CHURCH OF THE MAGDALEN ADDITION
WICHITA, SEDGWICK COUNTY, KANSAS

RE: SUB 2000-24 -- **REVISED** Final Plat of CHURCH OF THE MAGDALEN ADDITION

RE: SUB 2000-24 -- Final Plat of CHURCH OF THE MAGDALEN ADDITION

CASE NUMBER: SUB 2000-24 -- CHURCH OF THE MAGDALEN ADDITION

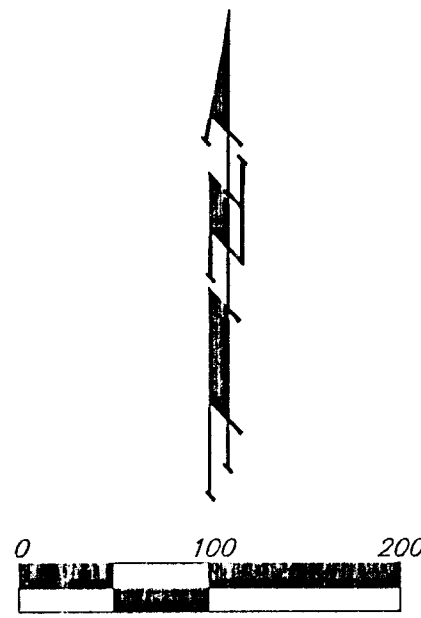
- A. As this site is adjacent to Wichita's city limits, the Applicant shall submit a request for annexation. Upon annexation, the property will be zoned SF-6, Single-Family Residential.

- B. City Engineering needs to comment on the need for guarantees or easements. The Applicant shall provide a guarantee for the extension of sanitary sewer and City water services.

- D. City/County Engineering needs to comment on the status of the applicant's drainage plan. County Engineering has required a copy of the final drainage plan to verify how off-site drainage is to be handled. City Engineering has approved the drainage plan and has required a cross-lot drainage easement. The minimum building elevation appears to be too low.

- E. County/Traffic Engineering needs to comment on the access controls. The plat proposes two access openings along 21st Street North and two access openings along 127th Street East. County Engineering requests that the entry access be coordinated with the streets and entrances on the south side of 21st Street. On the final plat, the dedication of access controls shall be referenced in the plat's text.

- F. County/Traffic Engineering needs to comment on the need for any improvements to perimeter streets. The Applicant shall provide a guarantee for the construction of a left turn bay on 21st Street and the construction of a paved road to County standards on 127th Street East along the plat's frontage.

- G. County Surveying requests a benchmark elevation.
- H. Access to 127th Street East will require a release to cross the pipeline.
- I. The applicant shall submit a covenant regarding the ownership and maintenance of the proposed reserves.

- J. In the plat's text, the word "Reserve" shall be corrected.
- K. The 35' building setback lines along the tapers on the road rights-of-way need to be parallel with the new property lines.

- L. The 35' building setback along 127th Street needs increased to include the pipeline setback with a definite dimension with respect to the plat.
- M. For those reserves being platted for drainage purposes, the required covenant which provides for ownership and maintenance of the reserves shall grant, to the City, the authority to maintain the drainage reserves in the event the owner(s) fail to do so. The covenant shall provide for the cost of such maintenance to be charged back to the owner(s) by the governing body.

- N. The applicant shall submit a copy of the instrument which establishes the pipeline easements on the property, which verifies that the easements shown are sufficient and that utilities may be located adjacent to and within the easements.

- O. The plat's text shall include language that a drainage plan has been developed for the plat and that all drainage easements, rights-of-way, or reserves shall remain at established grades or as modified with the approval of the applicable City or County Engineer, and unobstructed to allow for the conveyance of stormwater.
